Work Order ID 73607

Item Name: Crosstube Turning Detail

DART AEROSPACE LTD	Work Order: 73607
Description: Crosstube Assembly (205/212/412 High Fwd)	Part Number: D212-664-141
Inspection Dwg: D212-664-141 Rev: D	Page 1 of 1

DRAWING NO. D212-664-141	TITLE XTUBE ASSY (205/212/412 HI FWD)	REV. D	DART AEROSPACE LTD ENGINEERING ORDER		D.E.O. NO. D212-664-141-D-1	SHEET NO. SHEET 1 OF 2	SCALE NTS
DRAWN	CHECKED	OP	MFG. APPR.	APPROVED	DE APPR.		
DATE 11.04.07	DATE 11.07.11		DATE 11.04.12	DATE 11/04/12	DATE 11.04.12

**D212-664-141/-141B
ASSEMBLY DETAIL**

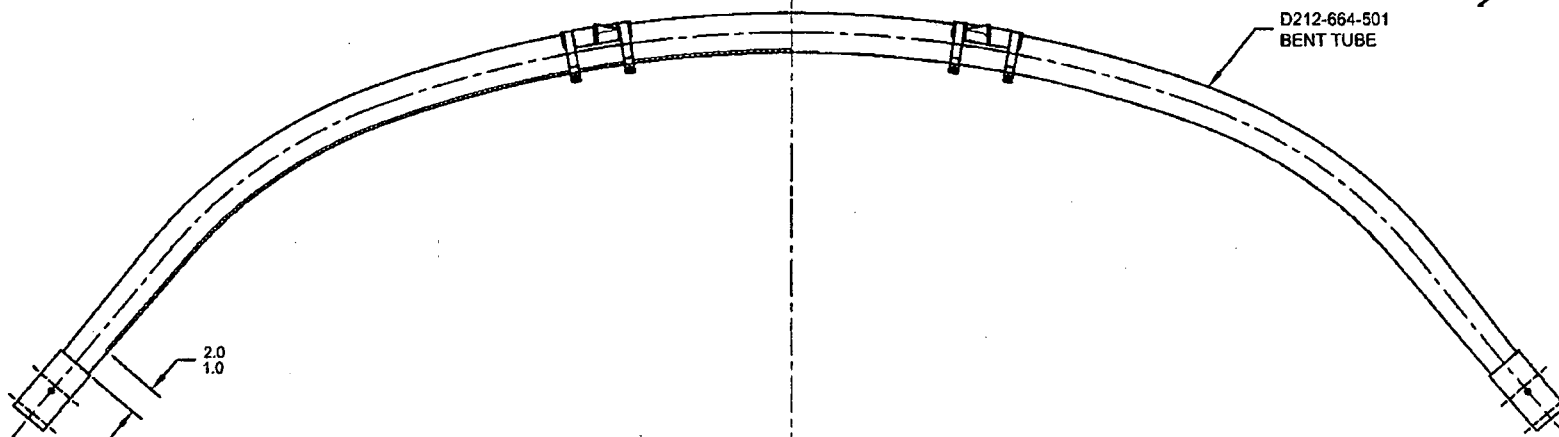
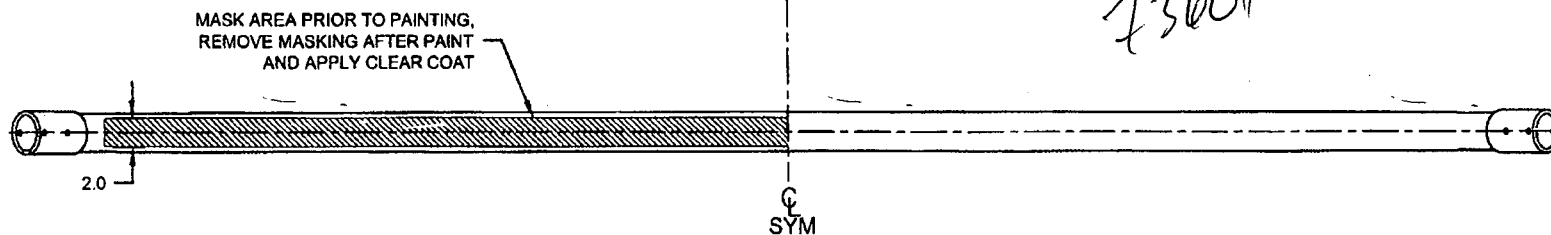
PURPOSE:

ADD AN INSPECTION WINDOW TO UNDERSIDE OF CROSSTUBE.

NOTES 2 OF SHEET 1 IS AMENDED AS FOLLOWS:

- 2) FINISH: CHEMICAL CONVERSION COAT PER DART QSI 005 4.1
PRIME INSIDE AND OUTSIDE PER DART QSI 005 4.2
MASK UNDERSIDE OF CROSSTUBE AS SHOWN (HATCHED AREA) AND
PAINT OUTSIDE PER DART QSI 005 4.2
REMOVE MASKING AND APPLY CLEAR COAT

- 2) FINISH: CHEMICAL CONVERSION COAT PER DART QSI 005 4.1
PRIME INSIDE AND OUTSIDE PER DART QSI 005 4.2
PAINT OUTSIDE PER DART QSI 005 4.2
